# HARNETT CENTRAL PRESS BOX

HARNETT CENTRAL PRESS BOX  
HARNETT COUNTY SCHOOLS  
2911 HARNETT CENTRAL RD, ANGIER, NC 27501

PROJECT INFORMATION:  
DATE: 1/10/2023  
DRAWN BY: RDH  
CHECKED BY: JEL  
SHEET TITLE  
COVER SHEET  
SHEET NUMBER  
G-001  
PROJECT# 21-11110

3 ROOF OVERHANG DETAIL  
SCALE: 1 1/2" = 1'-0"

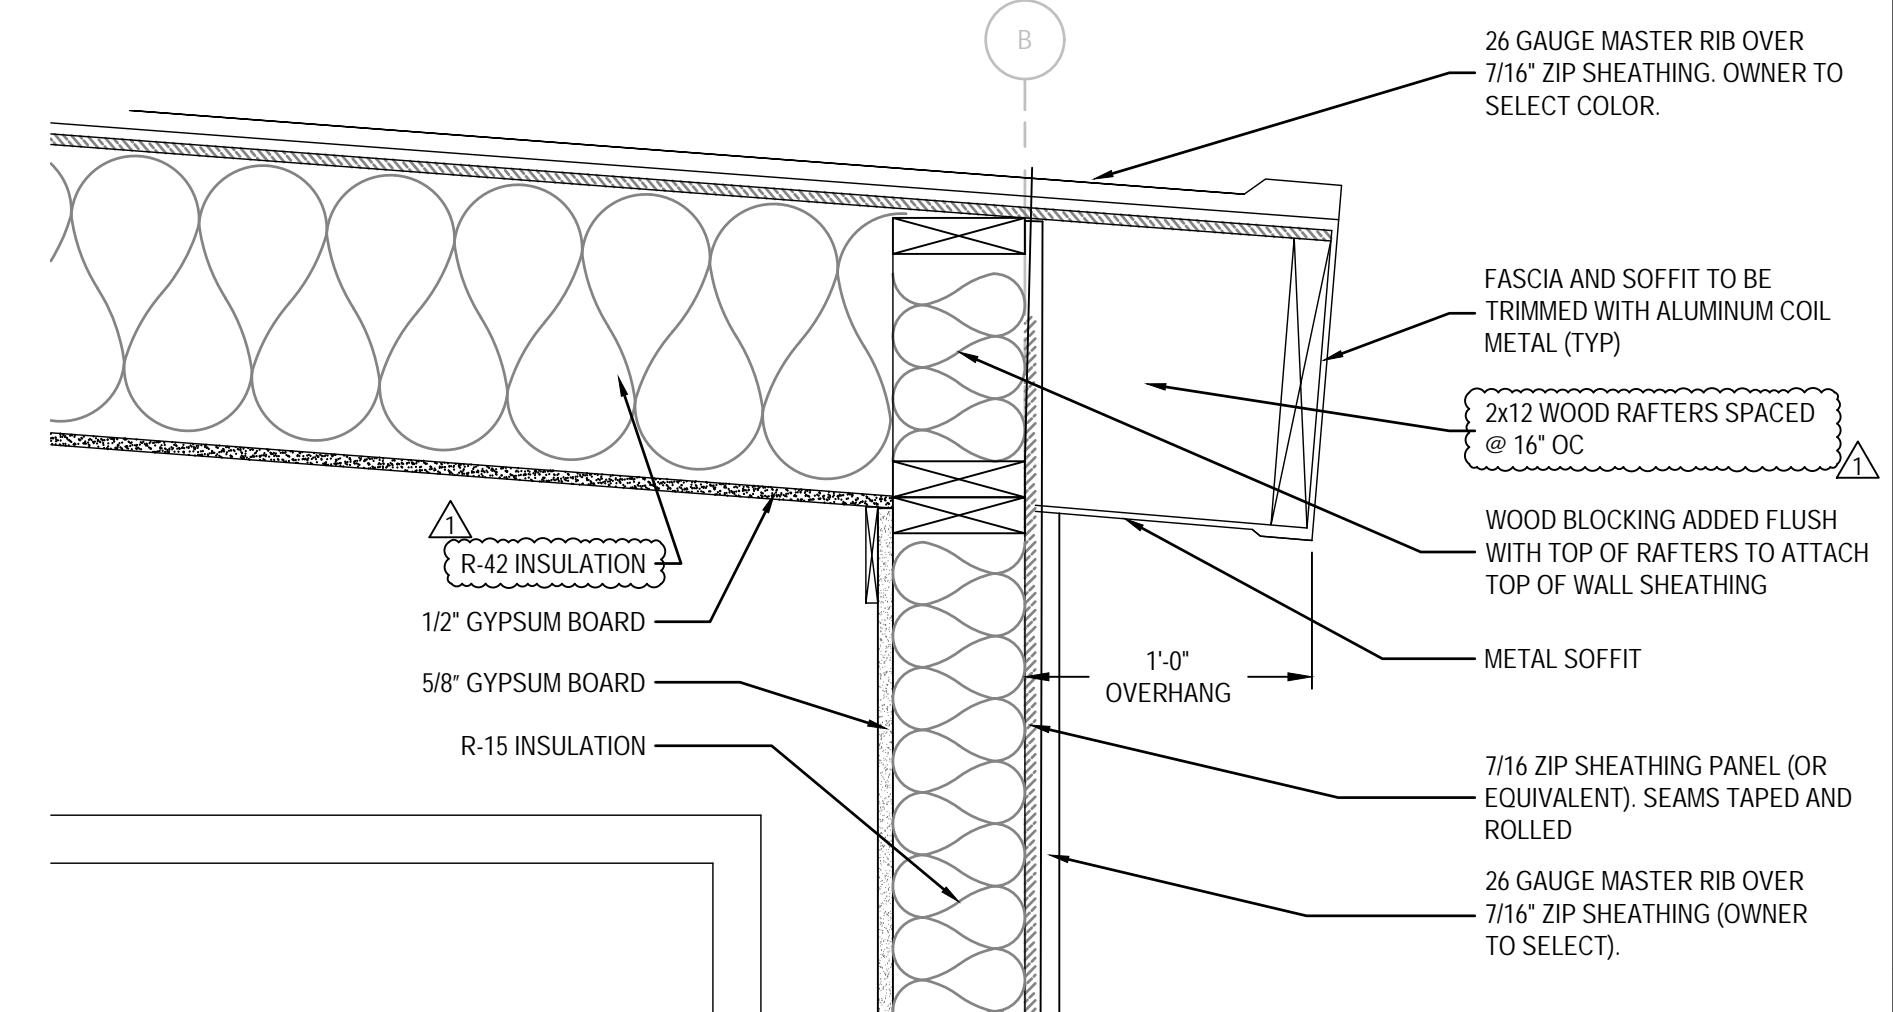
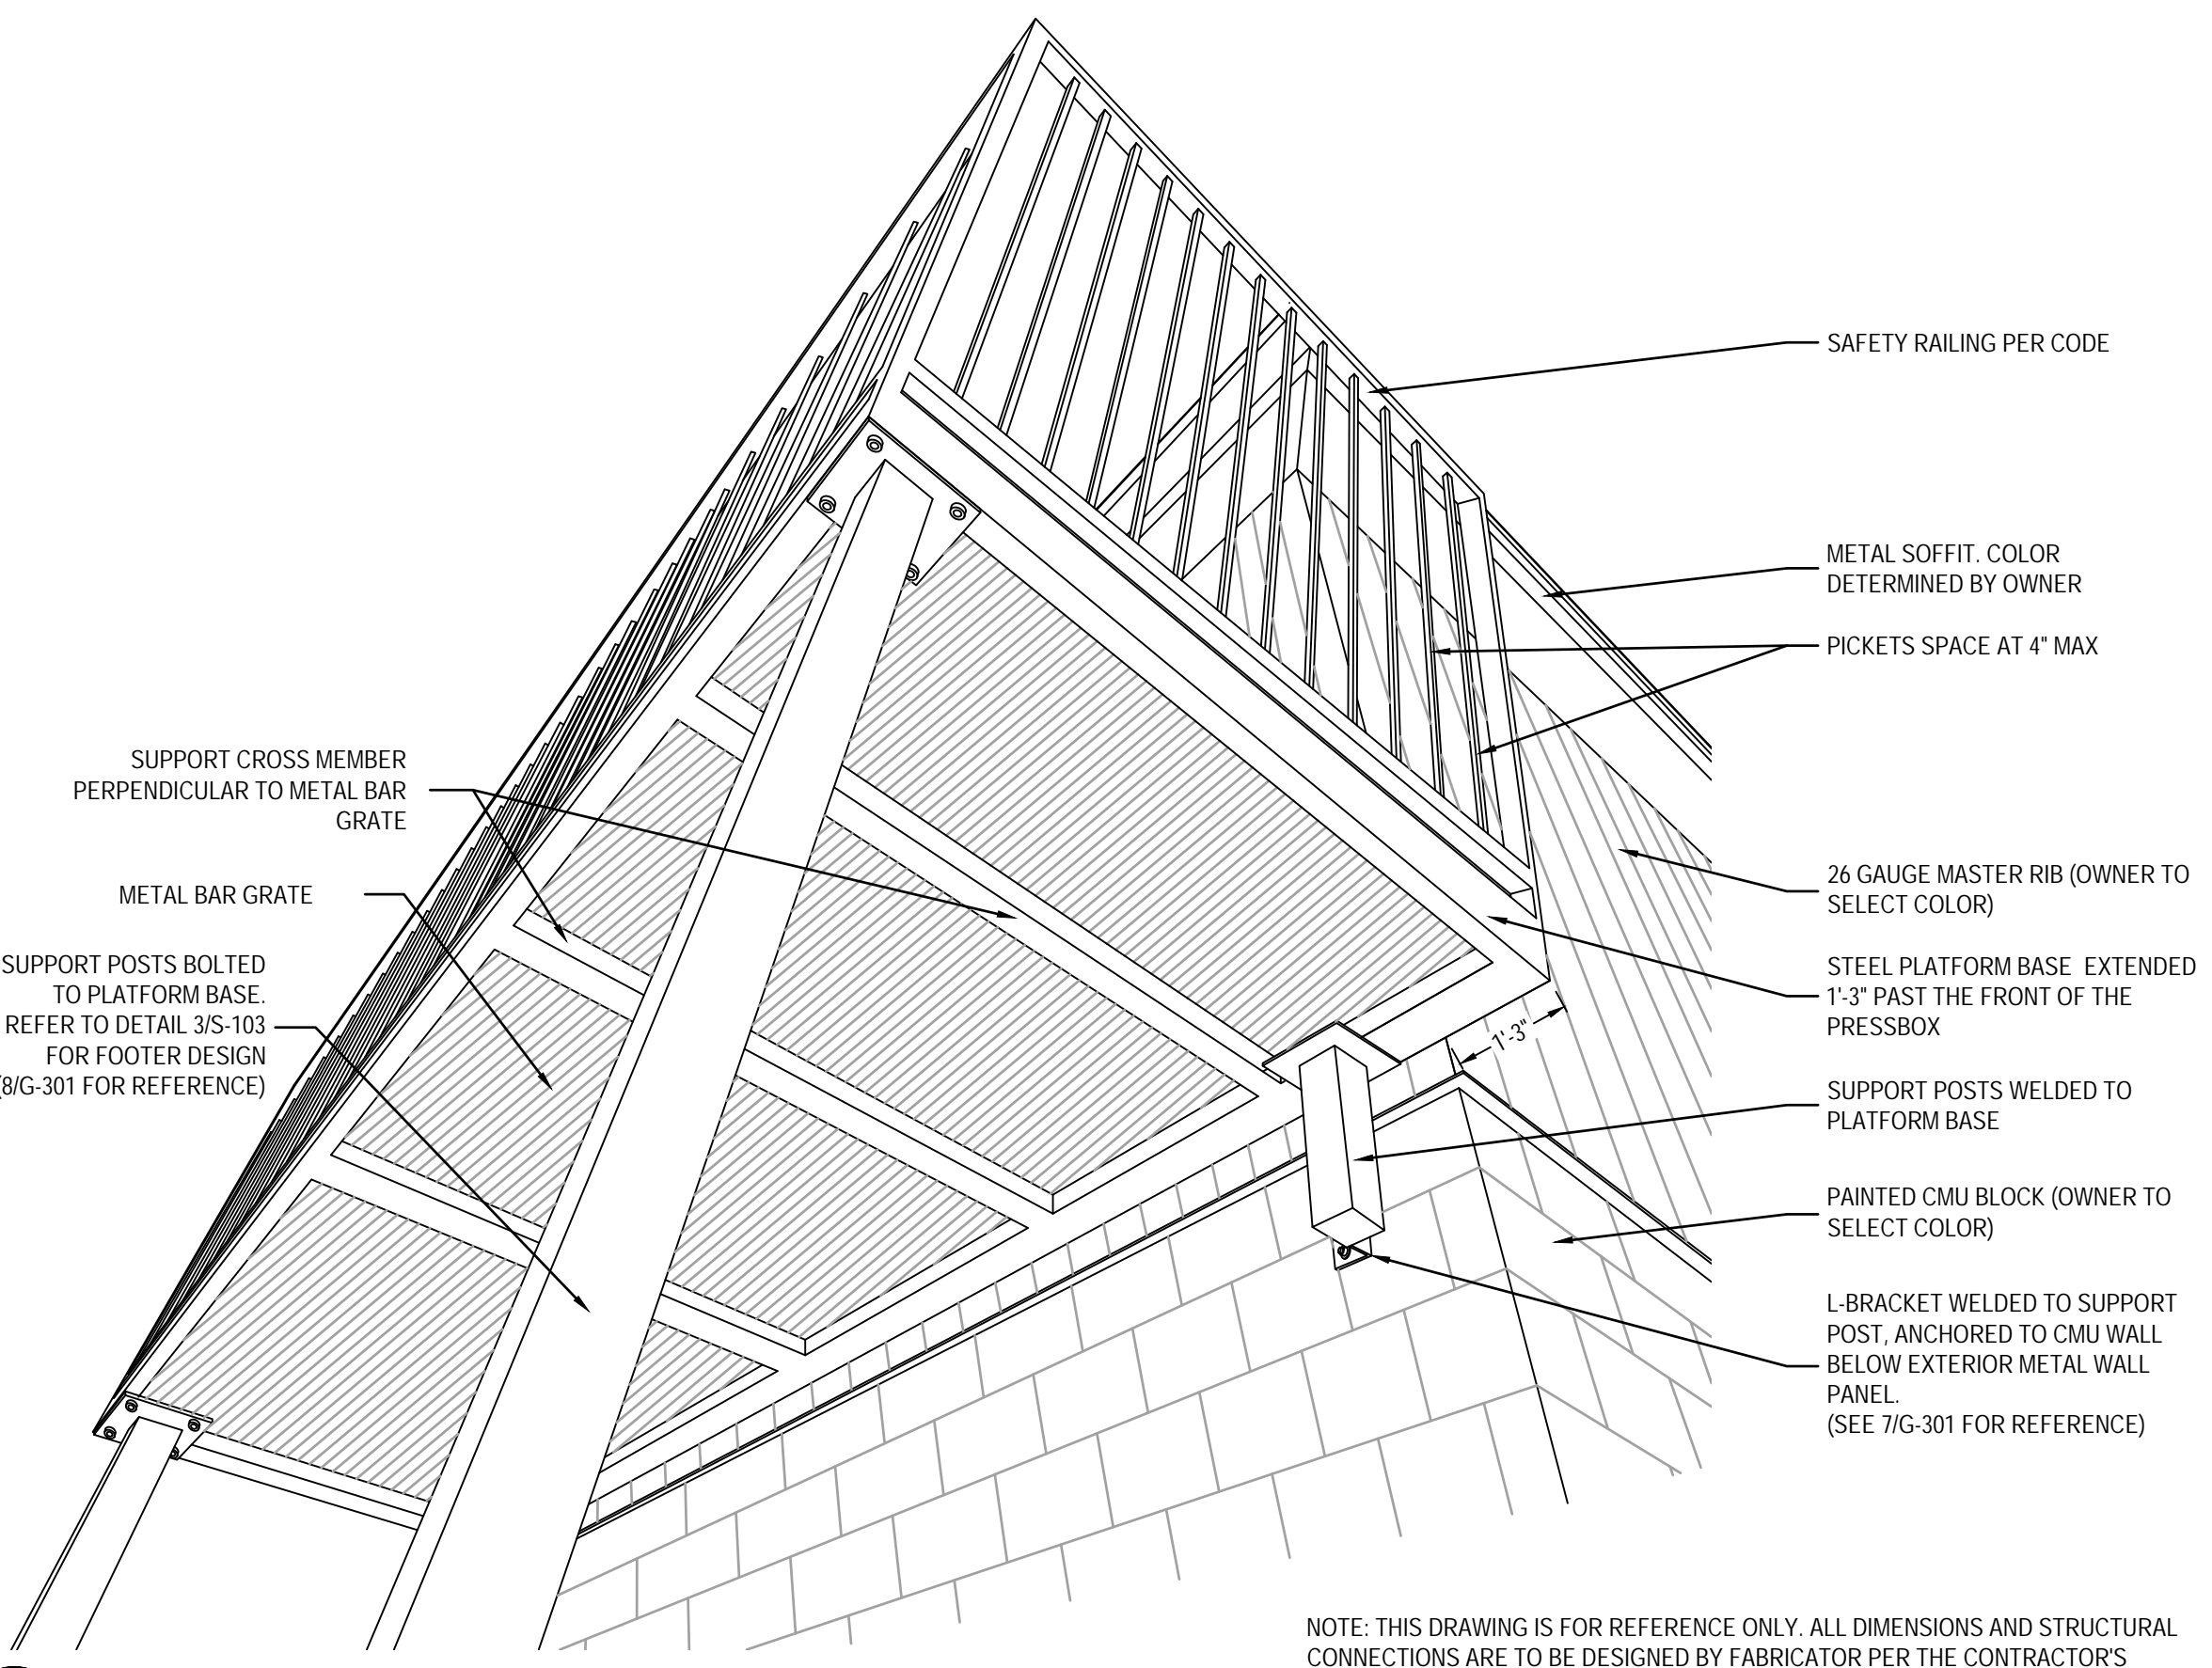
REVISION	DATE	DESCRIPTION
1	4/13/2023	ROOF RAFTERS AND INSULATION CHANGED; ELEVATIONS UPDATED.
2		
3		
4		
5
